**SUBJECT: Duke Power Company LLC d/b/a Duke Energy Carolinas, LLC
(Duke)
Oconee Nuclear Station, Units 1, 2, & 3
Docket Numbers 50-269, -270, -287
Relief Request 06-ON-004 Request for Additional Information**

OCONEE NUCLEAR STATION
RESPONSE TO
REQUEST FOR ADDITIONAL INFORMATION
REQUEST FOR RELIEF No. 06-ON-004
Pressurizer Alloy 600 Weld Overlays
(TAC Nos. MD2887, 2888, 2889)

Figure 1 Residual Stress Distribution from White Paper (see Text)

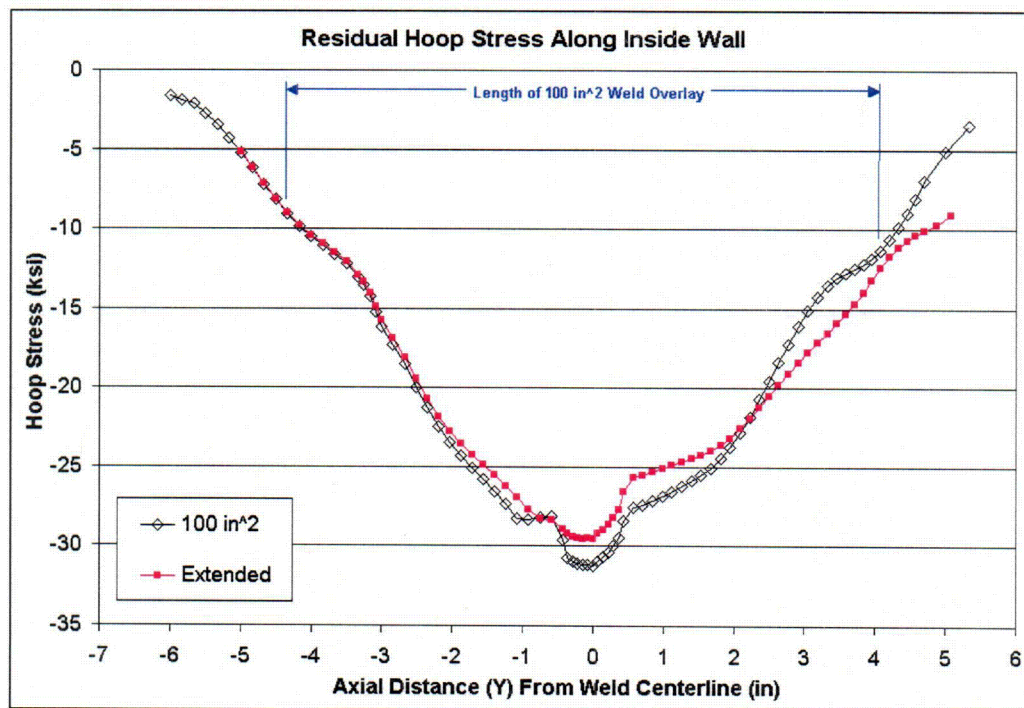
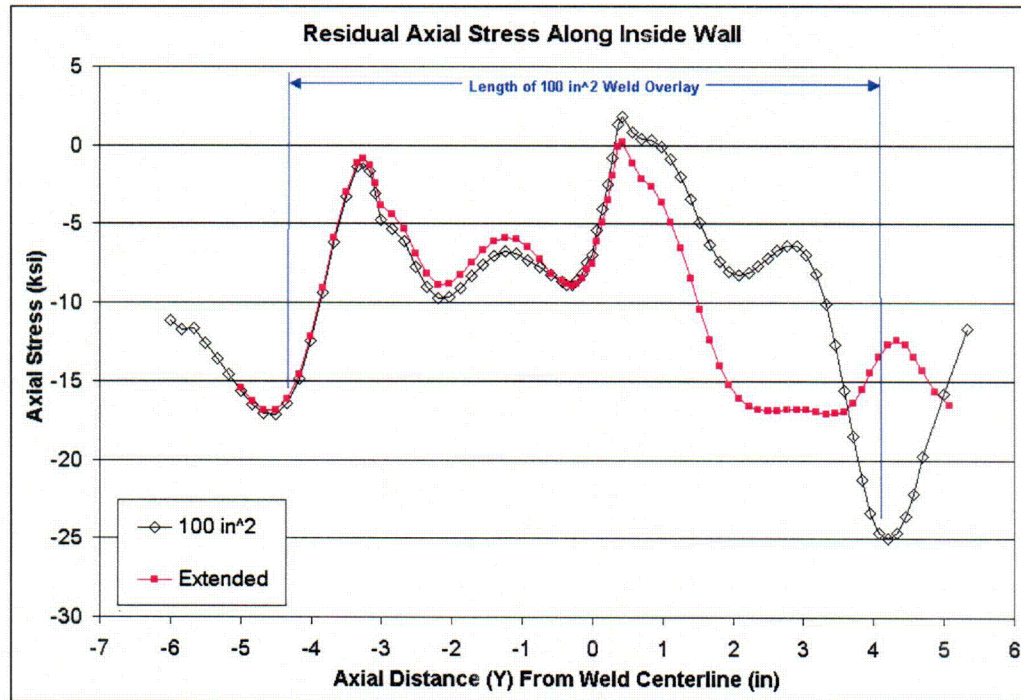
4. On page 5 of your submittal, you indicate that Code Case N-638-3 was recently approved by ASME, increasing the limit for temper bead welding over ferritic material. In your Table 3 list of alternatives you cite N-638-3 and the associated white paper as the basis for your alternative to exceed 100 sq.in. The staff has not approved this Code Case in Reg. Guide 1.147, Rev 14., and as such, the staff may take considerable time to evaluate your alternative. Another approach may be to provide a basis that is consistent with other alternatives that the staff has approved. Part of your discussion should include similarities between your plant and those listed in your precedents section of the submittal and why the resultant overlay will not prevent the component from performing its design function.

(a) Residual Stresses – Using as an example a BWR Feedwater Nozzle, the white paper cites EPRI sponsored analyses [1] of an overlay that just equaled 100 in² coverage over the ferritic steel base metal. Two axisymmetric finite element models were created, one with the 100 in² weld overlay and the other with the weld overlay extended on the nozzle side until it blended into the nozzle taper surface (approximately 126 in²). Figure 1 shows the post overlay residual stress on the nozzle inside surface for both models. It is seen that the extended overlay configuration did not significantly alter the residual stress results, and if anything, made the axial stresses even more compressive.
